Informal document No. **9**
(50th GRE, 7-11 April 2003,
agenda item 3.2.)

“CUT-OFF” LINE IN AFS DRAFT REGULATION

EXPLANATION TO INFORMAL DOCUMENT No. 8

INFLUENCE OF TOLERANCES OF VERTICAL AIMING ON LIGHTING RANGE AFS CLASS C (BASIC) PASSING BEAM

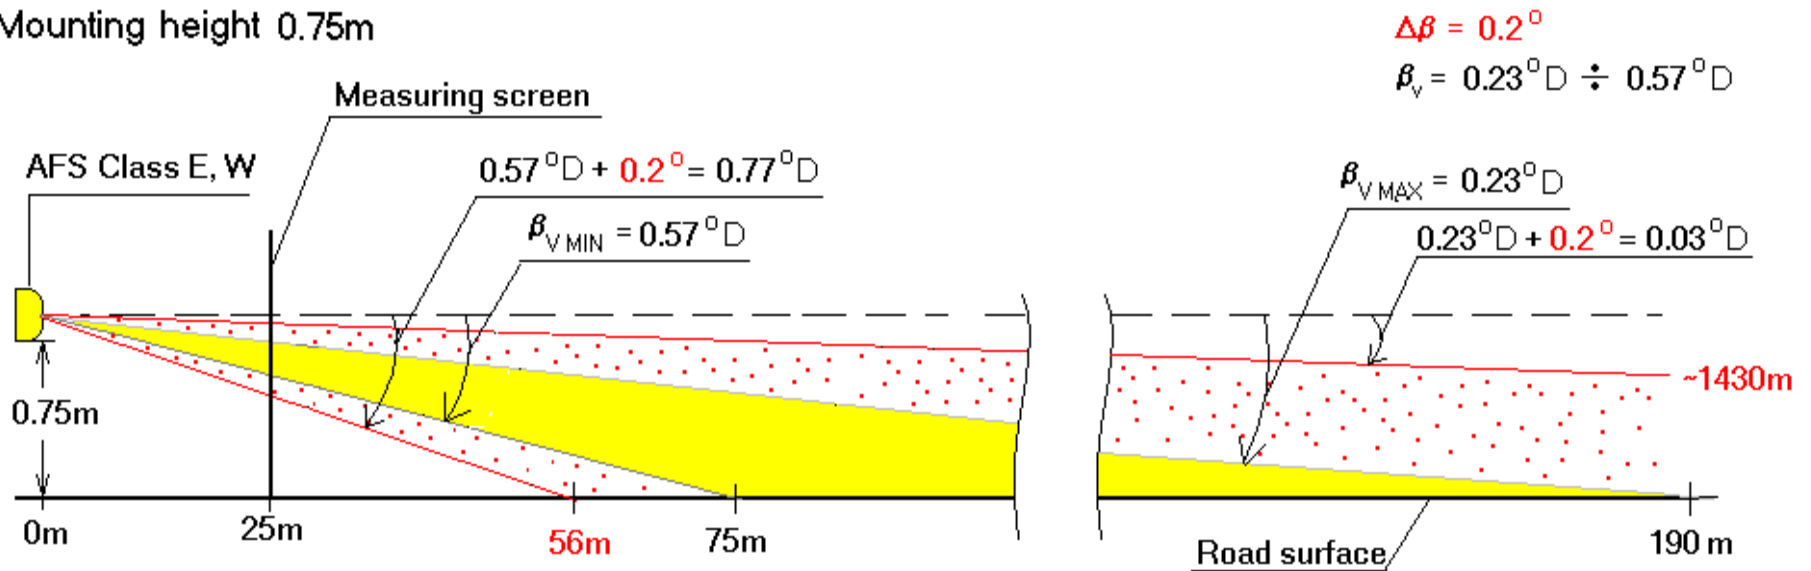
- Annex 9 P. 1.2.1. the "horizontal part" does not exceed a vertical extent of $\Delta\beta = 0.2 \text{ deg}$ up or down*
- Annex 3 Table 2 Class C (basic): the "cut-off" shall be positioned at 0.57 deg*

In case of using a standard headlamp at standard mounting height at 0.75m, assuming „cut-off” line tolerance of $\Delta\beta = 0.2 \text{ deg}$, lighting range will vary 56m to 116m, which can be accepted.

INFLUENCE OF TOLERANCES OF VERTICAL AIMING ON LIGHTING RANGE

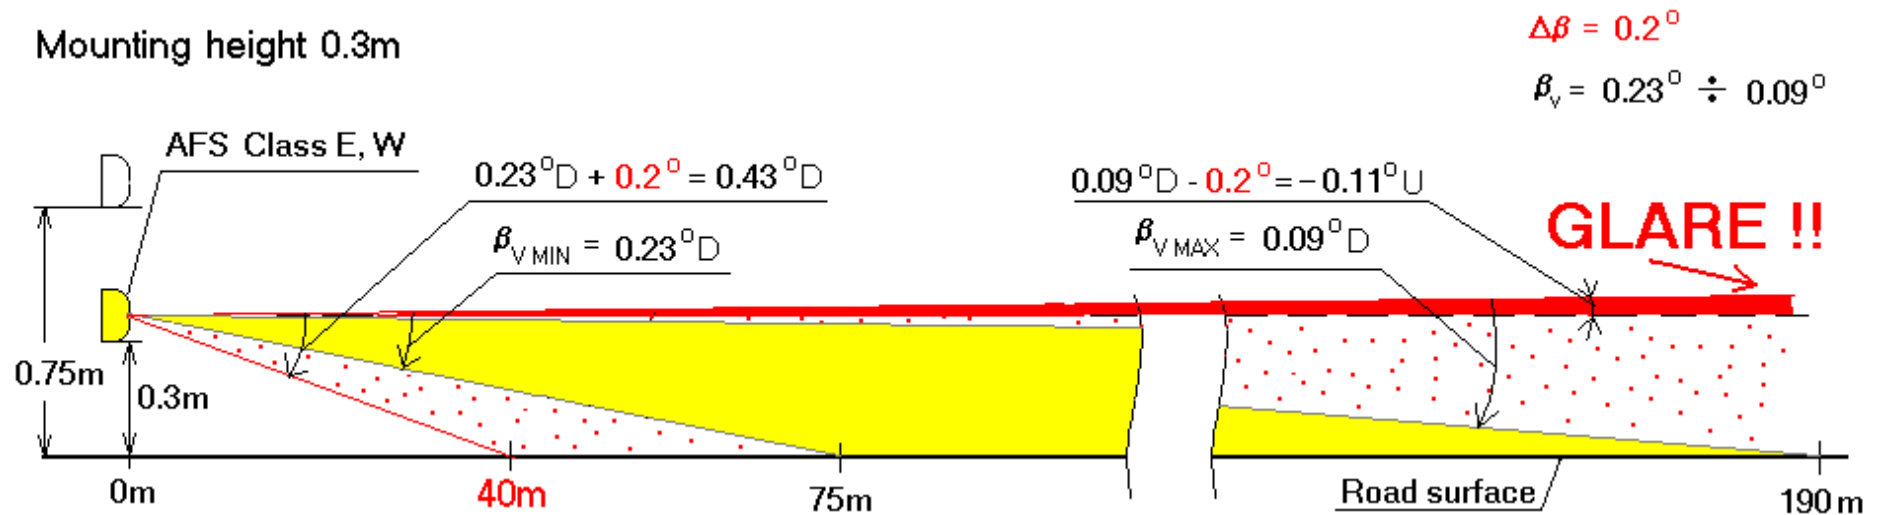
Annex 3 Table 2 Class E (motorway) and W(wet road):

the "cut-off" shall be positioned not above 0.23deg and not below 0.57deg

In case of using AFS Class E and W passing beams of one pair of lighting units **at standard height of 0.75m**, lighting range will vary from 56m to 1430m (considering rising of the beam from 0.57degD to 0.23degD) when tolerance of vertical aiming is **$\Delta\beta = 0.2\text{deg}$** .

INFLUENCE OF TOLERANCES OF VERTICAL AIMING ON LIGHTING RANGE

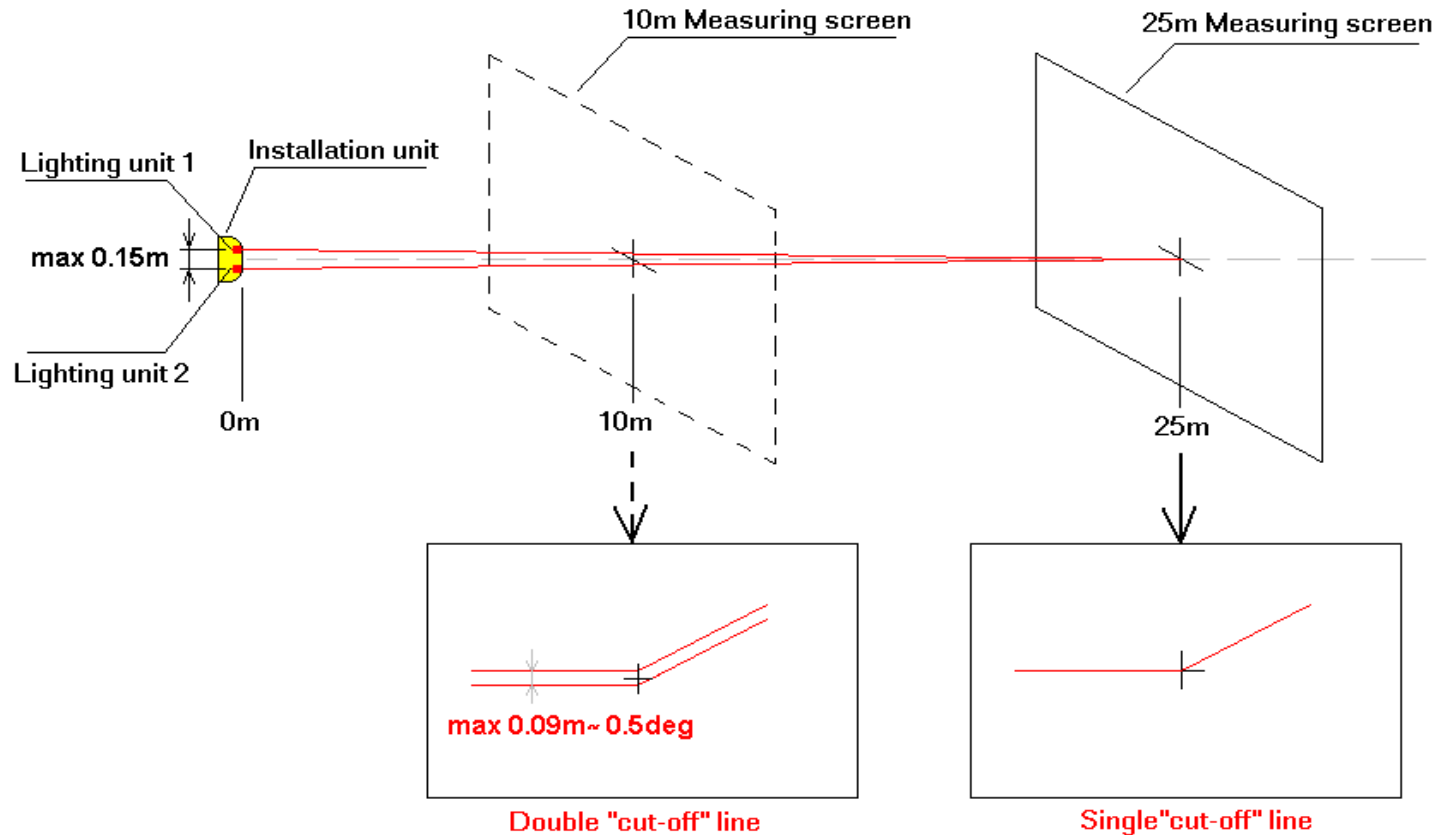
To obtain **the same lighting range** for AFS lighting units mounted at **0.3m** as for AFS lighting units mounted at standard mounting height 0.75m, the “horizontal part” shall be positioned not below $0.23\text{deg}D$ and not above $0.09\text{deg}U$.

Problems considering $\Delta\beta = 0.2\text{deg}$:

- lighting range on the road surface can change from 40m to „infinity”
- „cut-off” can be positioned over $0.43\text{deg}D$ and under $0.11\text{deg}U$ over horizon. This can cause direct intensive glare

Conclusion: „Horizontal part” of „cut-off” shall be aimed with tolerance of not more than $\Delta\beta = 0.1\text{deg}$.

DOUBLE „CUT-OFF” LINE PHENOMENON AIMING ON 10M MEASURING SCREEN

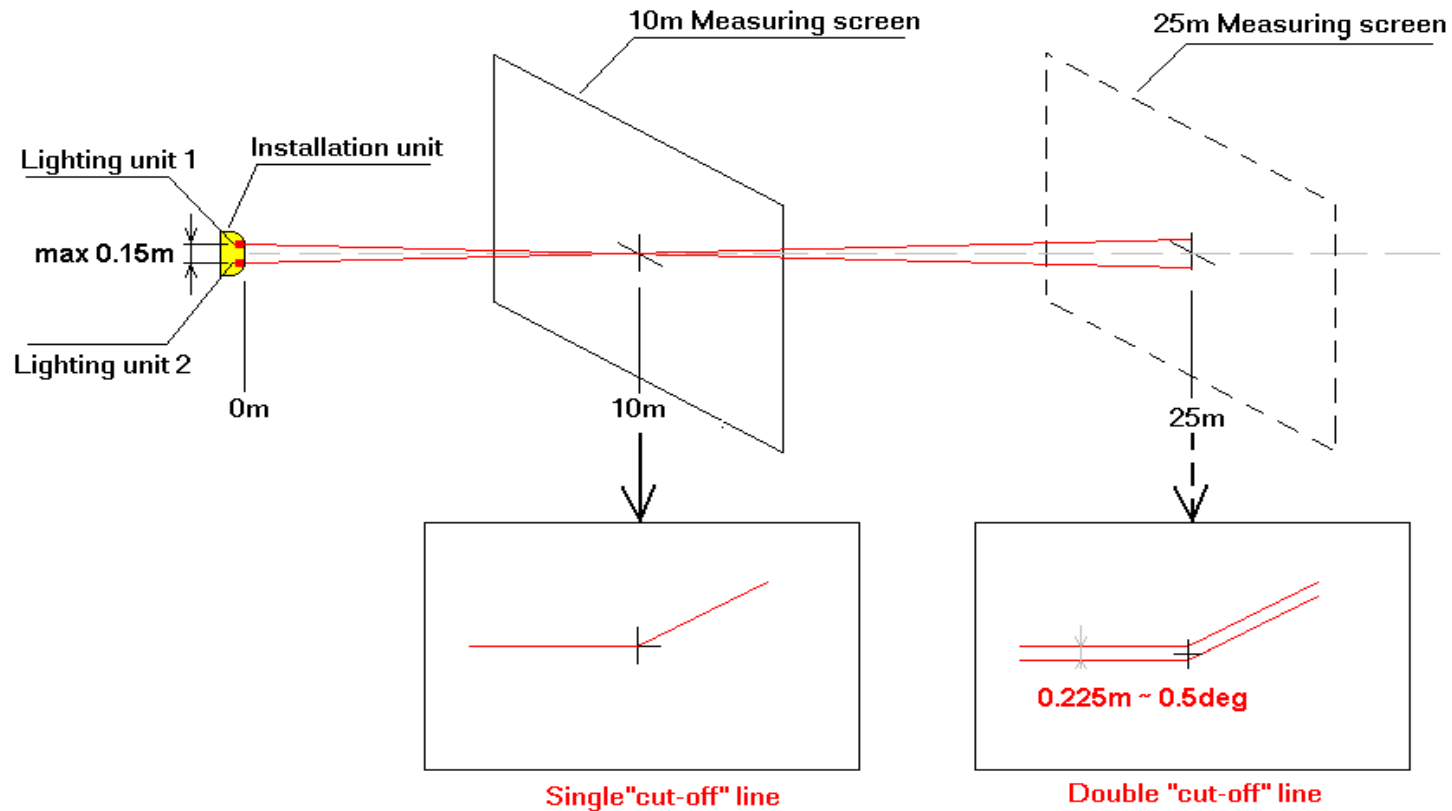
Double „cut-off” line can be the result of projection of „cut-off” lines coming from two or more lighting units.

Conclusion: “Cut-off” line of each lighting unit, and not “cut-off” line of passing beam or installation unit, has to be aimed separately to avoid multiple „cut-off” line problem.

PROPOSAL OF OF “CUT-OFF” LINE AIMING BEFORE MEASUREMENTS

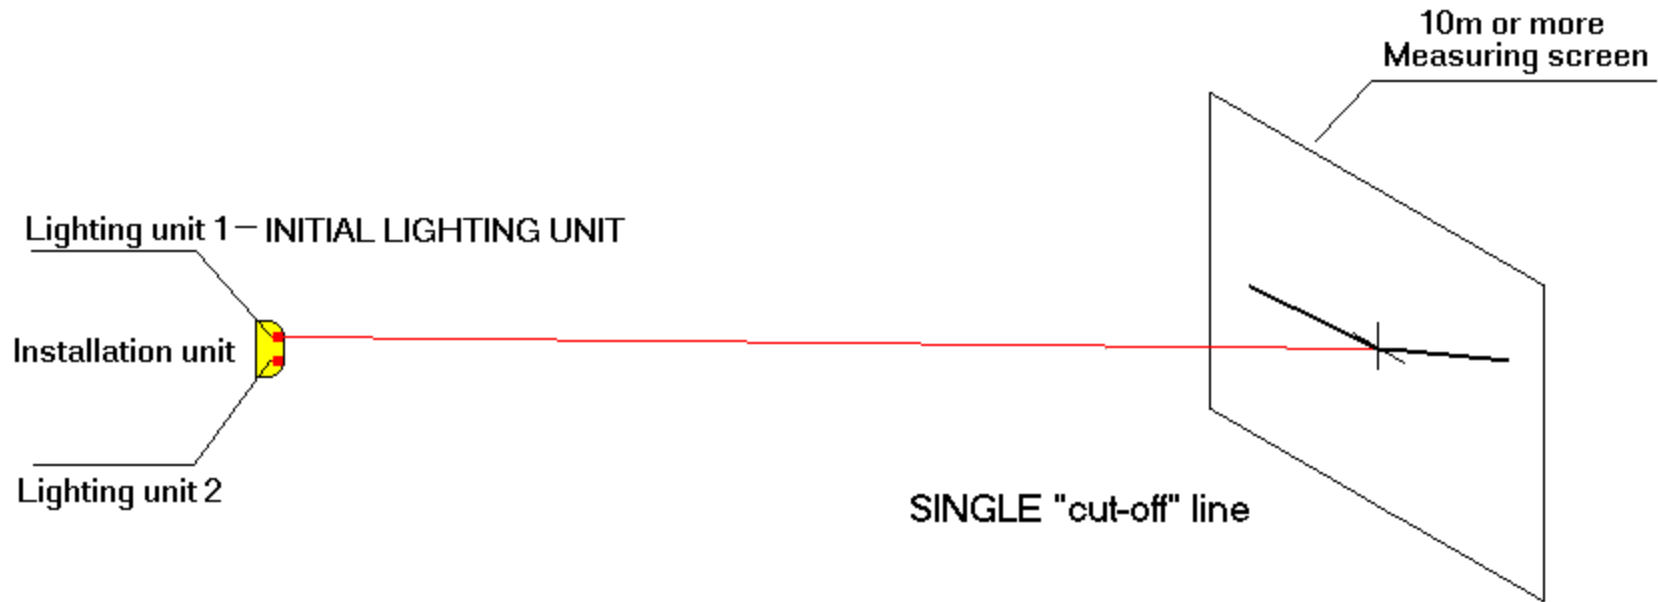
New definition: INITIAL LIGHTING UNIT - lighting unit specified by an applicant used for aiming the „cut-off” line before photometric measurements (TRANS/WP.29/GRE/2002/44rev.1)

Suggested procedure of aiming of the “cut-off” line:

1. Aiming the „cut-off” line for initial lighting unit.
2. Measuring the illumination E for lighting units incorporated in installation unit and not separately aimed.

AMBIGUITIES OF „CUT-OFF” LINE DESCRIPTION IN DRAFT XXX

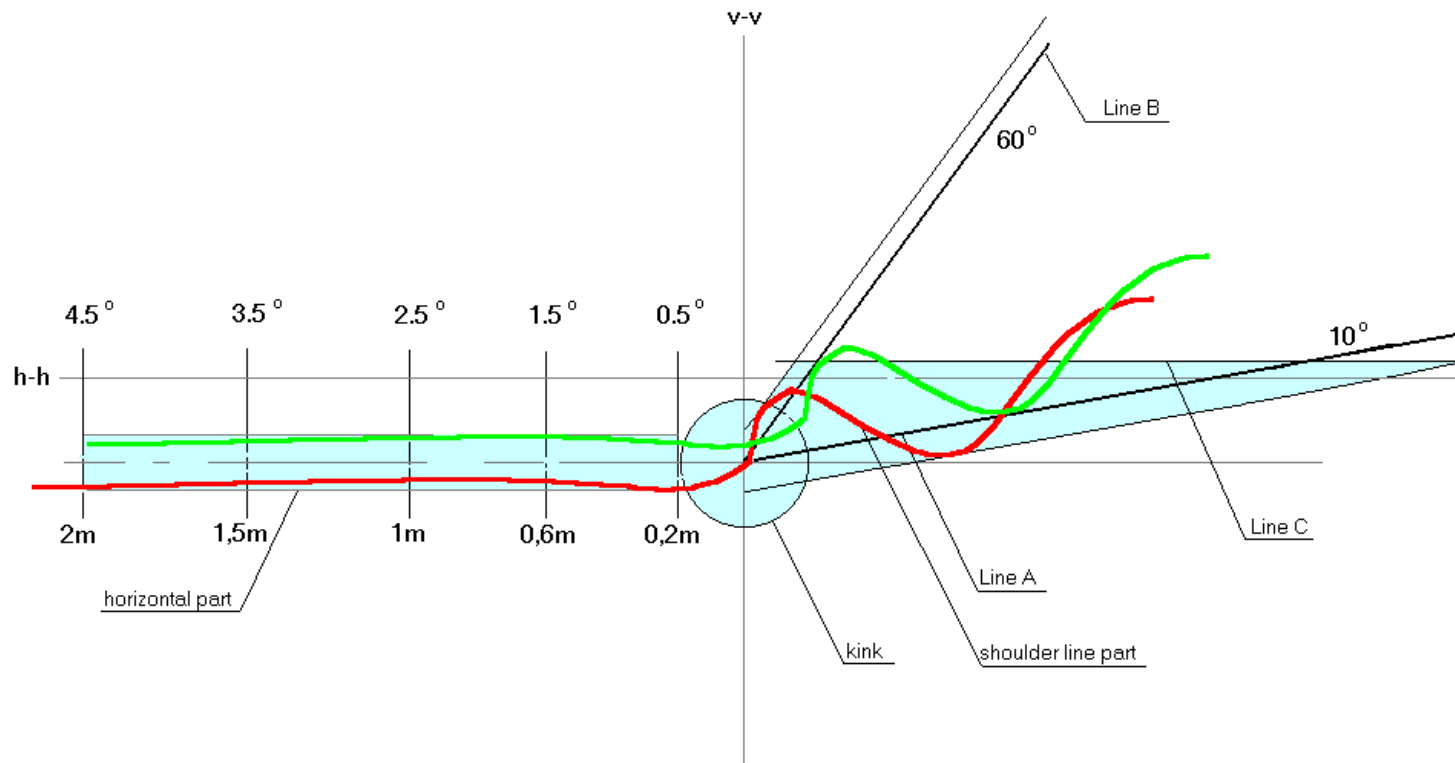
In many places of Draft XXX there is no clear distinction between “cut-off” line of **passing beam** and “cut-off” line of **lighting unit** e.g.:

Annex 9 P.1. The "cut-off" line of a passing beam shall comply with the following requirements ...

Annex 9 P.2.1 For lighting units contributing to the passing beam but providing no “cut-off” or a horizontal “cut-off” line only ...

Annex 9 P.2.3. For each class, other than the class C (basic) passing beam: the shape and position of the "cut-off", if any, shall comply ...

Conclusion: Description of “cut-off” line of lighting unit should only be used.

RESULTS DEPENDING ON USAGE OF „SHOULDER LINE PART” TOLERANCES

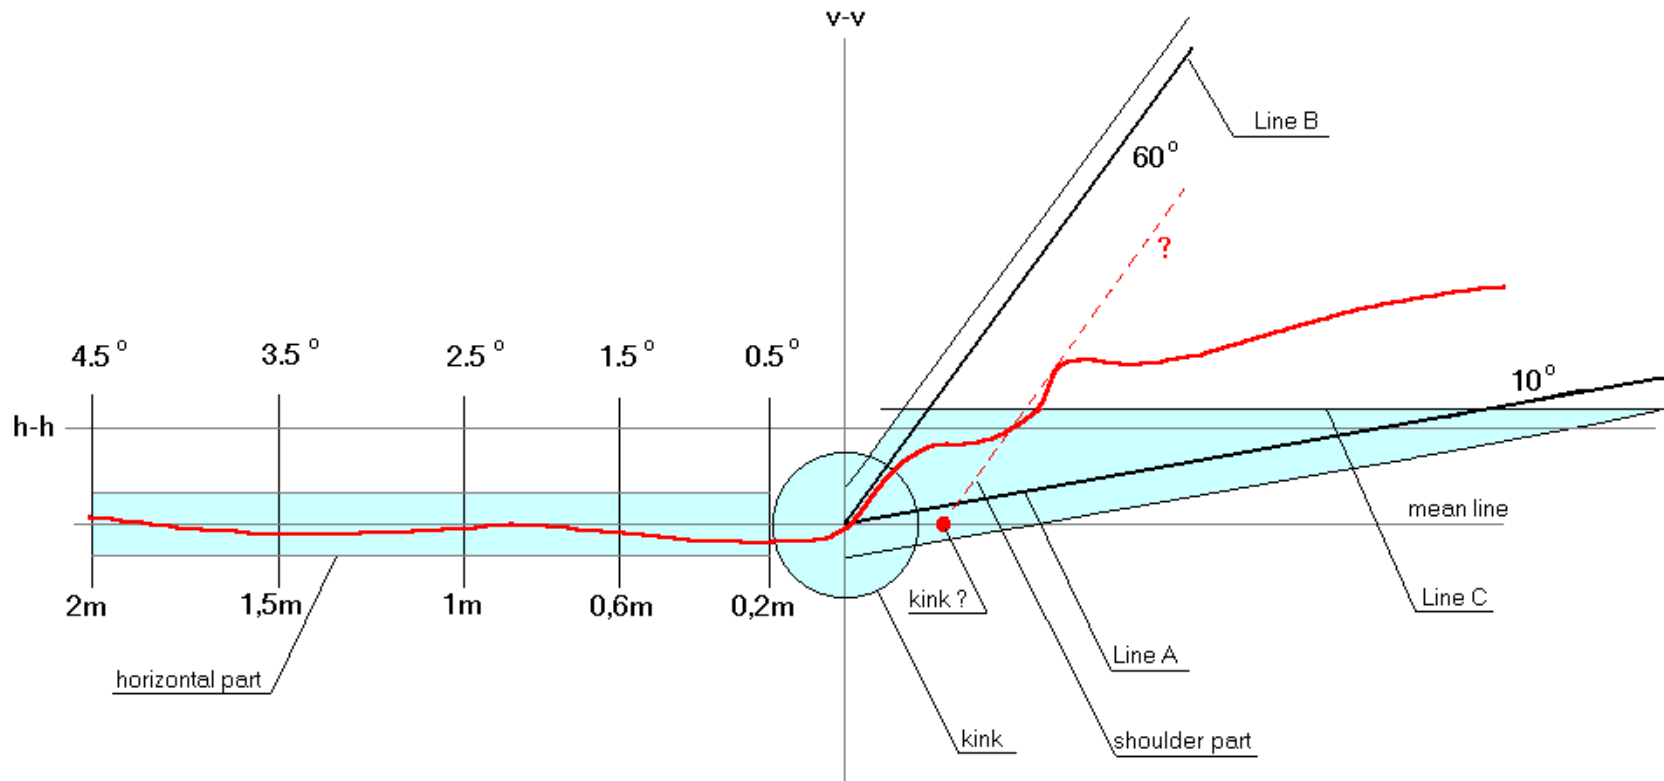
„Cut-off” line can be aimed differently depending on using or not using 0.2 deg tolerance of A and B lines:

1. If tolerances of lines A and B do not apply, green position “cut-off” line is obtained.
2. If tolerances of lines A and B apply, red position “cut-off” line is obtained.

Conclusion: Tolerances of A and B lines $\pm\Delta\beta$ lead to different results of „cut-off” line aiming.

Proposal: **Remove A and B lines $\pm\Delta\beta$ tolerances from Draft XXX.**
(as in TRANS/WP.29/GRE/2002/44rev.1)

POSITION OF 60DEG TANGENTIAL LINE

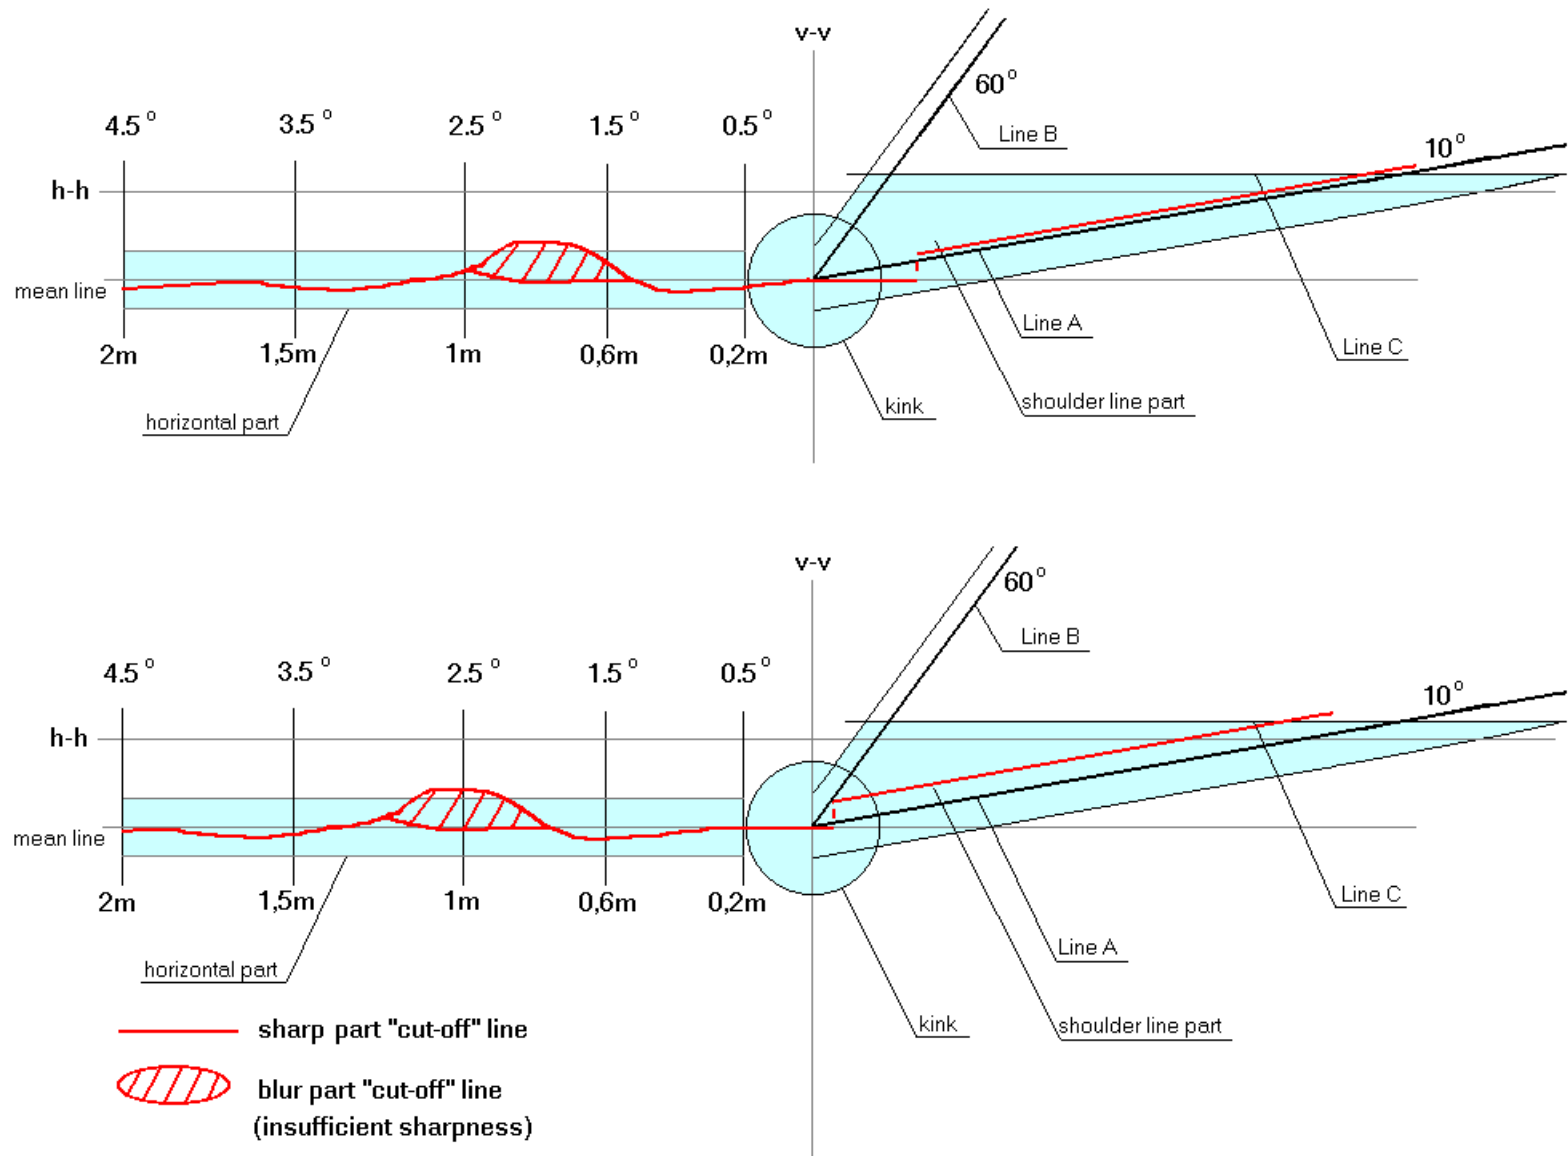
Some of lighting units can have more than one „kink point” in „cut-off” line and it is difficult to decide which one is correct with respect to the tangential line inclined 60 deg to the „shoulder line part”.

Proposal: „Shoulder part” shall be approximated by slant line.
 (Compare examples of “cut-off” line approximation)
